This document describes changes of the CTL-2000 Product HW revision from Rev 01.00 (PCB v1.3) to Rev 01.10 (PCB v1.7).

<b>Product Description:</b> CTL-2000 Main Board & Device	
<b>Product HW Revision:</b> Rev 01.00 to Rev 01.10	
<b>PCB Number:</b> EPCB-00156-001 Rev1.3, Rev1.4, Rev1.5, Rev1.7	
<b>PCBA Number:</b> EPCA-00125-101 rev 1.7	
<b>Instruction prepared by:</b>  Maryam Mesgari John Lopes	<b>Instruction date:</b>  5 / 10 / 2023

## Changes applied to Rev1.4 compare with Rev1.3:

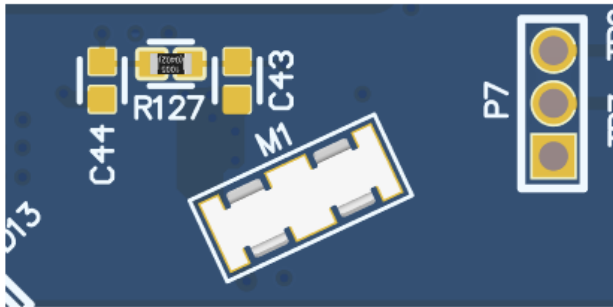
- 1- SD\_CLK and SD\_CMD connections to ESP32 GPIO pins swapped  
Only change in routing
- 2- R177=0R link added between ESP32 GPIO and PHY TXC pin

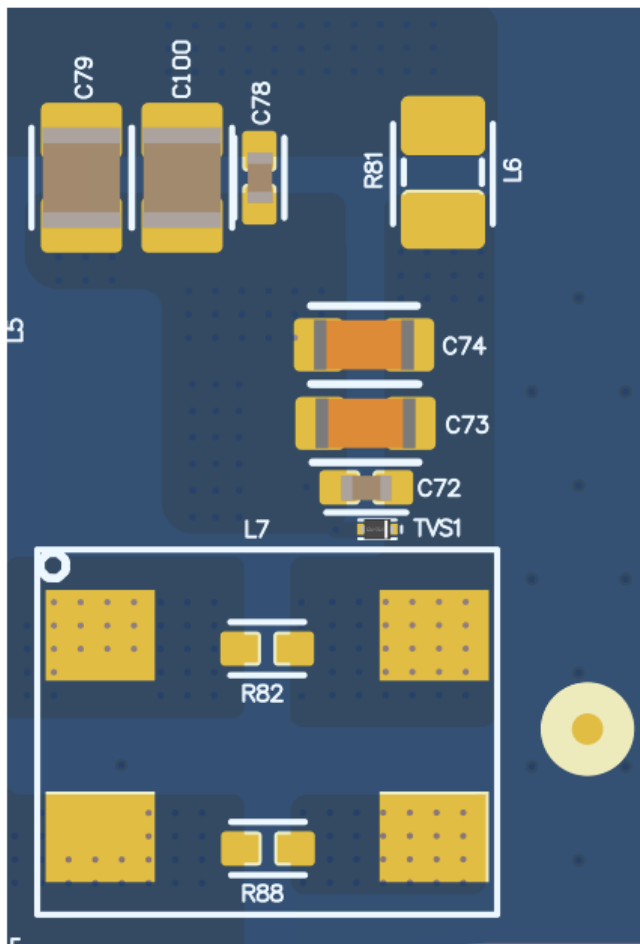
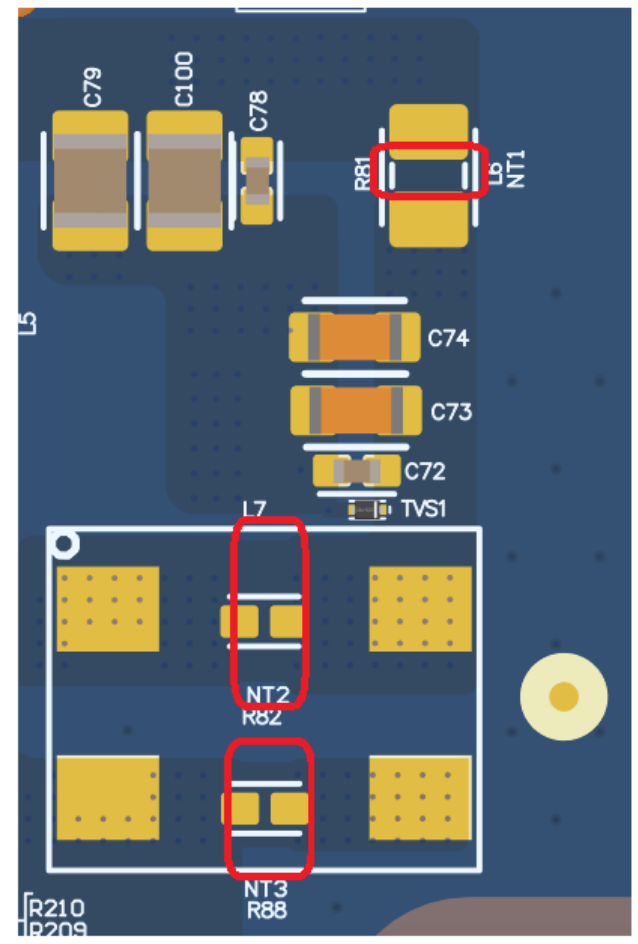
- 3- L6 and L7 are bypassed by Net-Tie

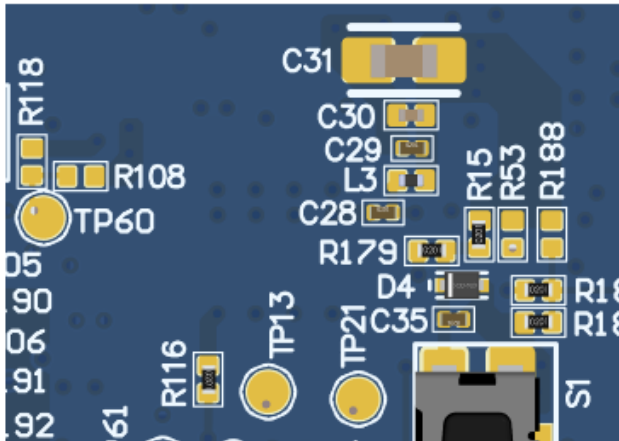
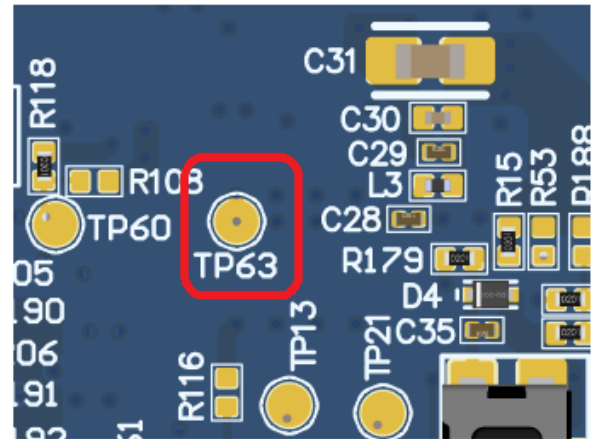
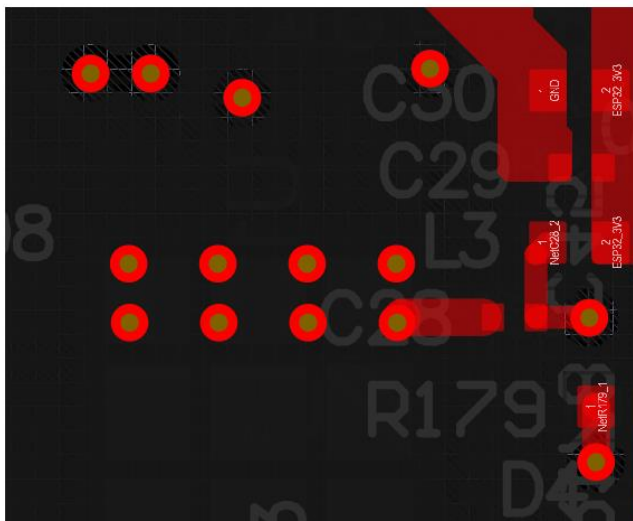
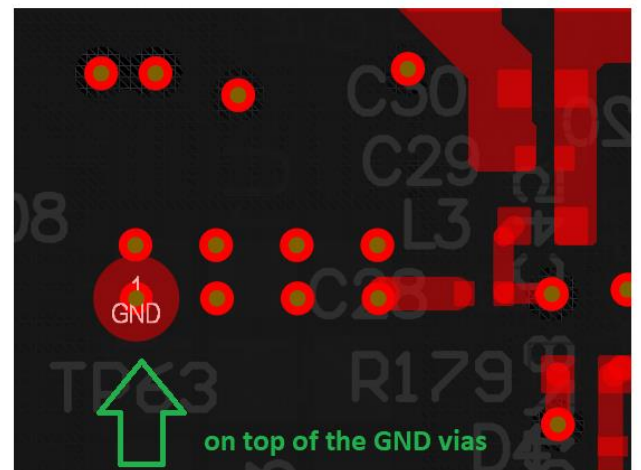
4- TP63 added on top of GND vias

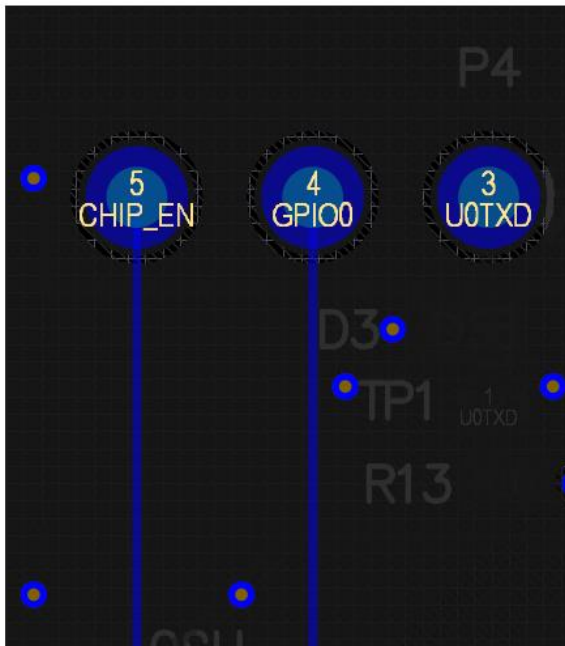
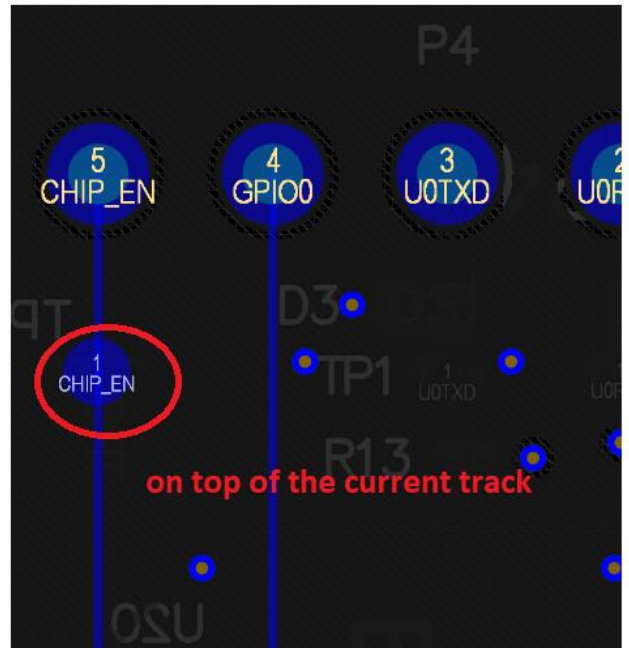
5- TP64 added on top of the current track

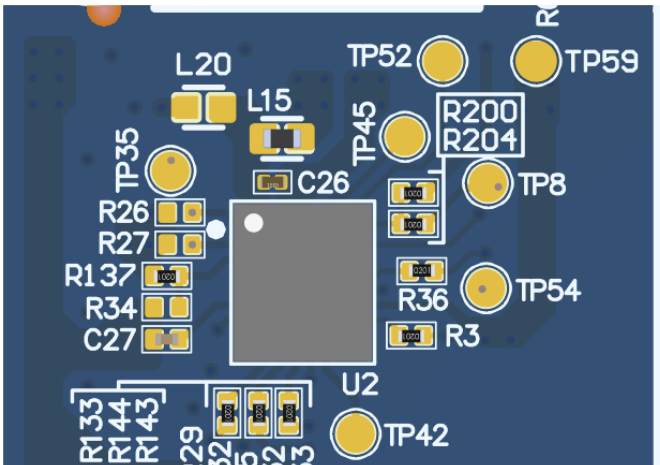
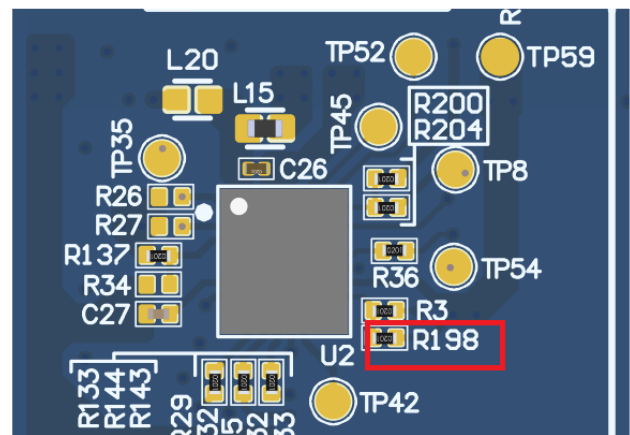
6- 10K pull-down resistor added for Sensor GPIO

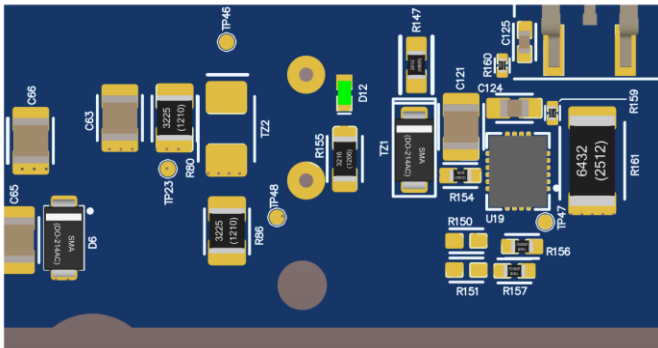
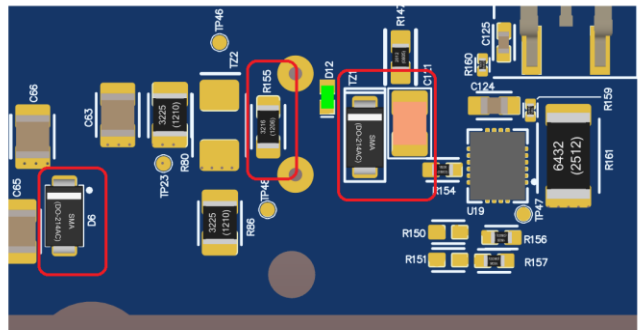
- 1- C121 had interference with heatsink (Shown in photo below)
- 2- 4 big Holes clearance should have been considered (3mm from the center on Top layer, and 4mm from the center on Bottom layer).

Rev1.5 Some components' locations shifted

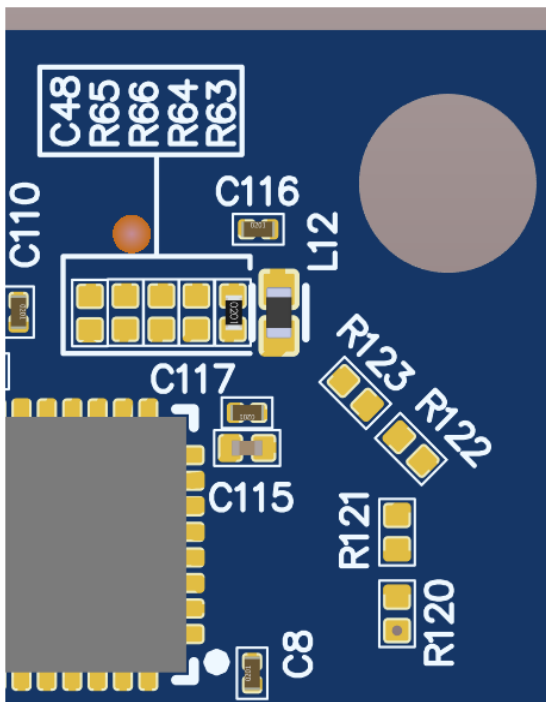
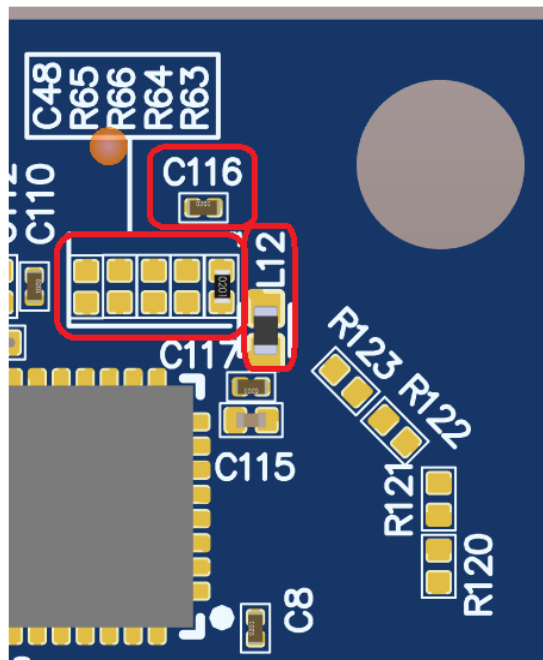
Rev1.5 (some components are slightly shifted)

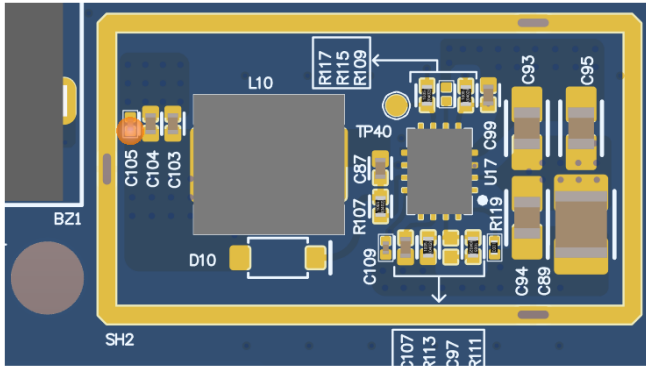
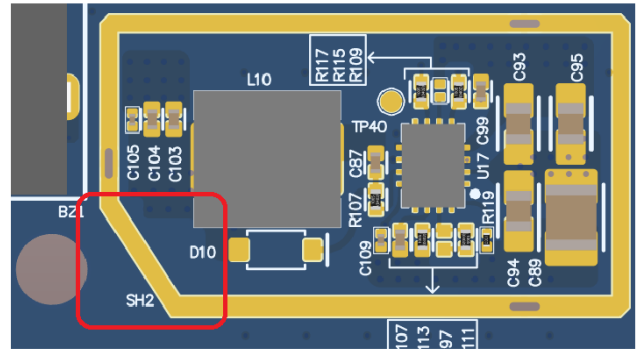
Rev1.5 (Shield can corner re-shaped)

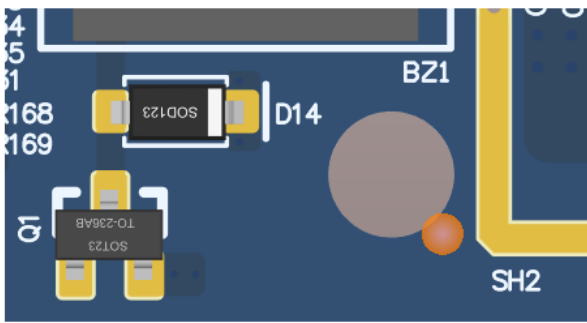
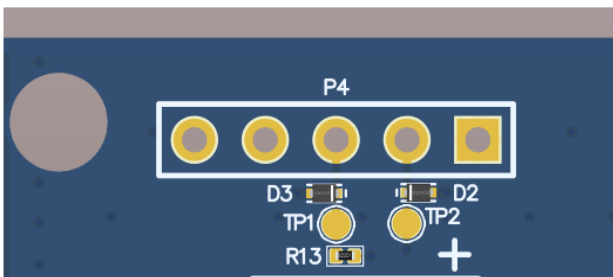
Rev1.5 (D14 slightly moved)

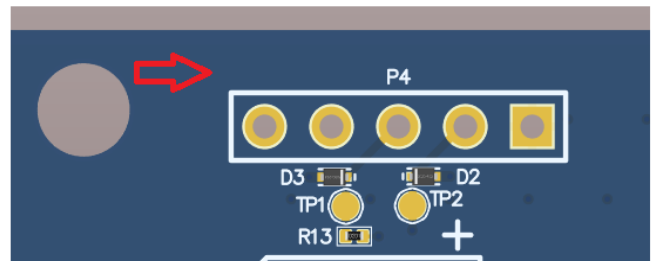
Rev1.5 (Header slightly moved)

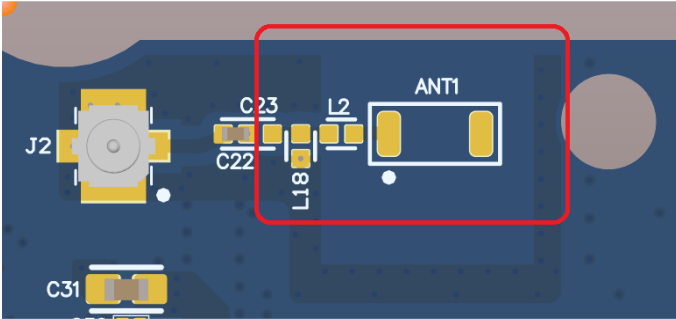
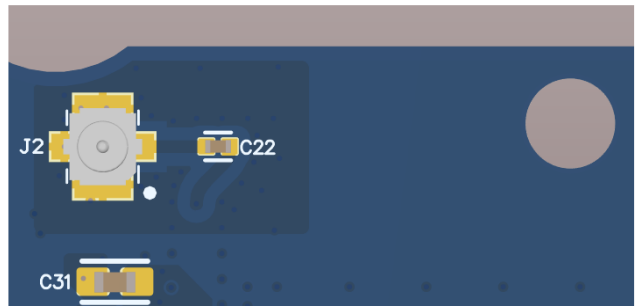
3- SMD chip antenna circuitry totally deleted. These parts were DNP on Rev1.4

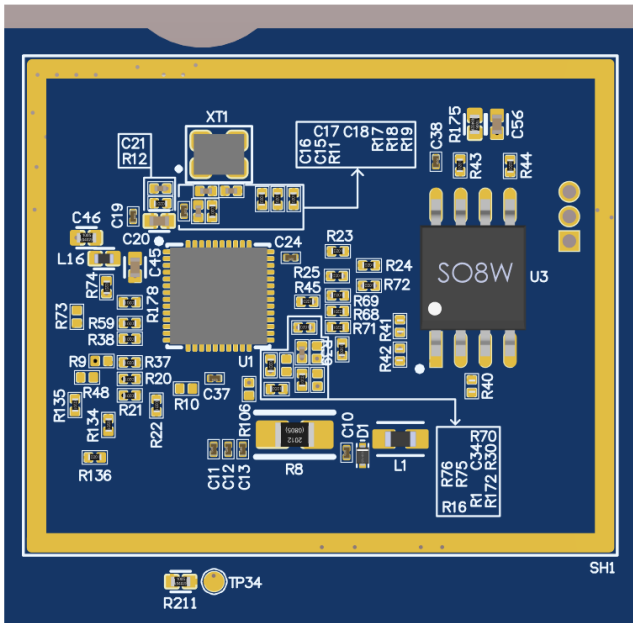
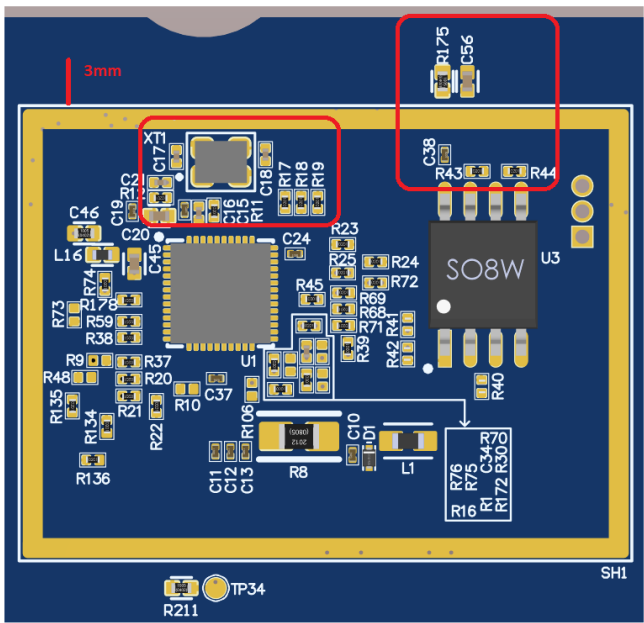
4- ESP32 shield can dimension reduced to remove the clashes

(some components had to be shifted)

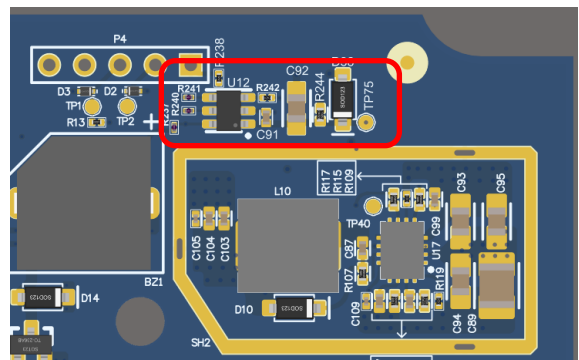
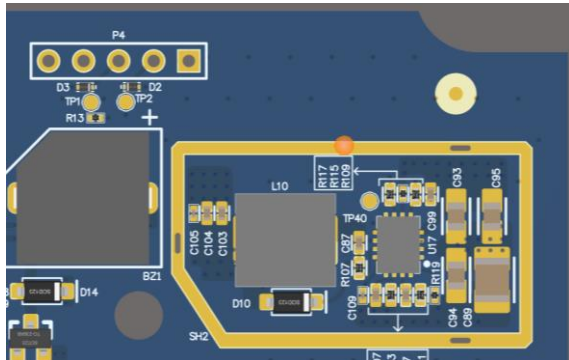
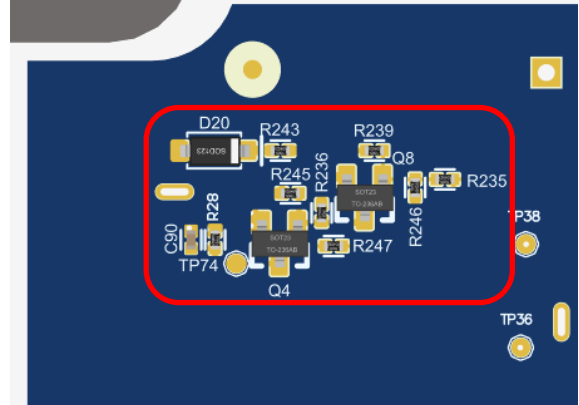
1. Hardware watchdog circuit (U12) and associated components added to recover from SW lockup.

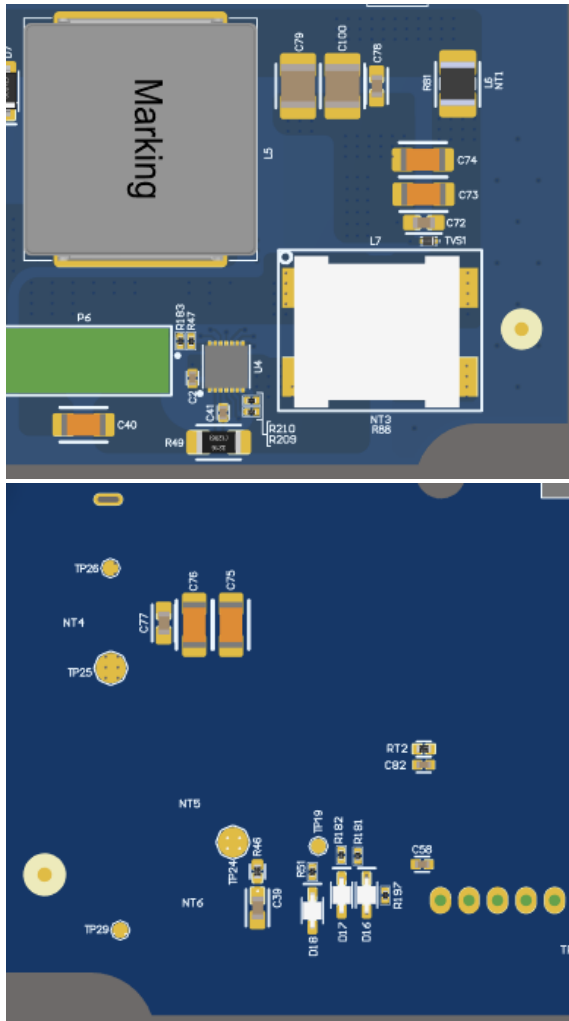
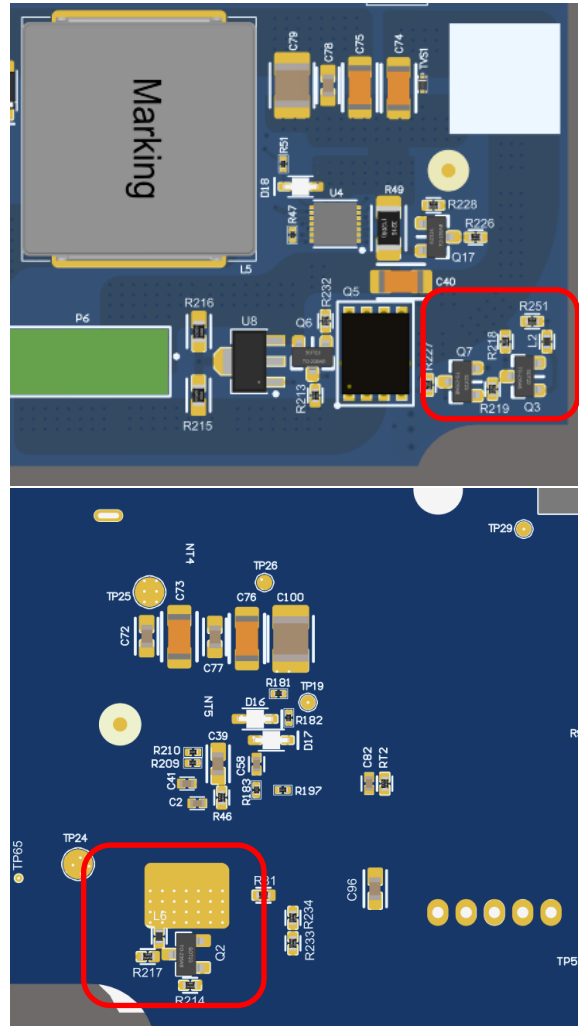
- FET power control circuit added (including components Q2, Q3, Q7) to LED board Connector added to save battery power in low power mode.

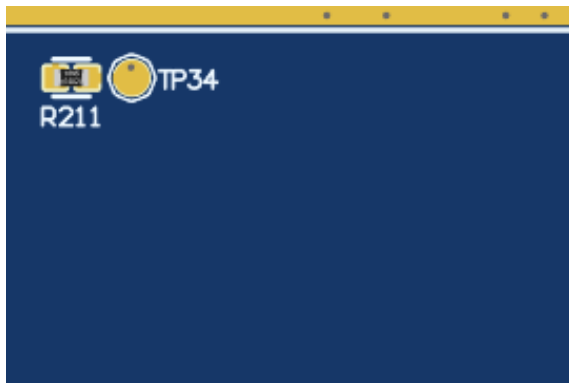
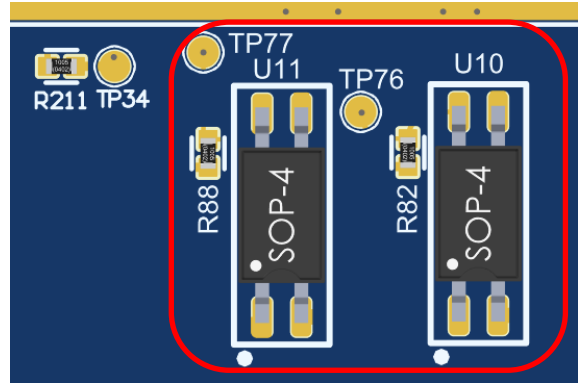
- 2 x Optocouplers (U11, U10) added to detect POE status.

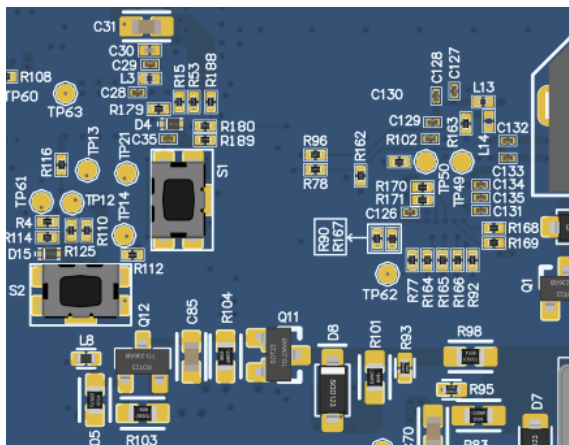
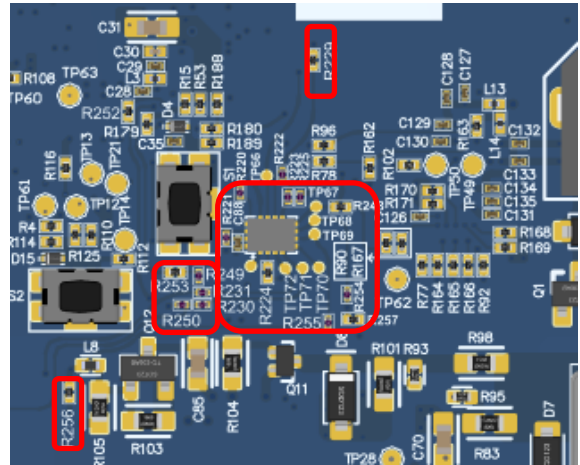
- I2C GPIO expander (U9) added to existing I2C bus to support additional GPIO for LED board FET control and HW Watchdog.

### LED Board Changes

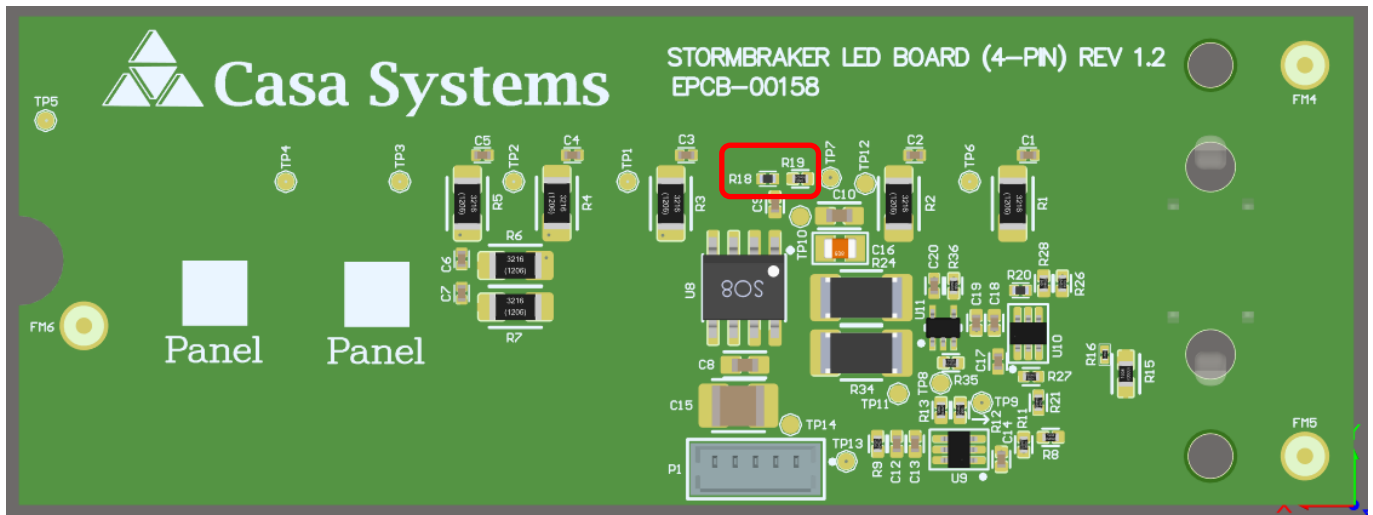
1. Resistor value changes (R18, R19) in linear voltage regulator circuit to reduce quiescent current draw.

### EPA Board Changes

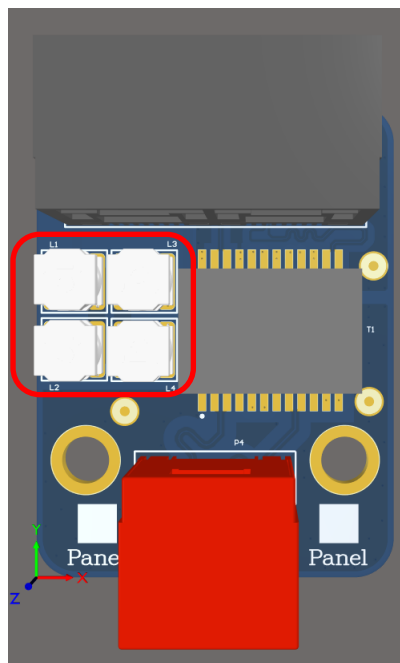
2. 4 x 150uH inductors (L1, L2, L3, L4) replaced with OR Resistors
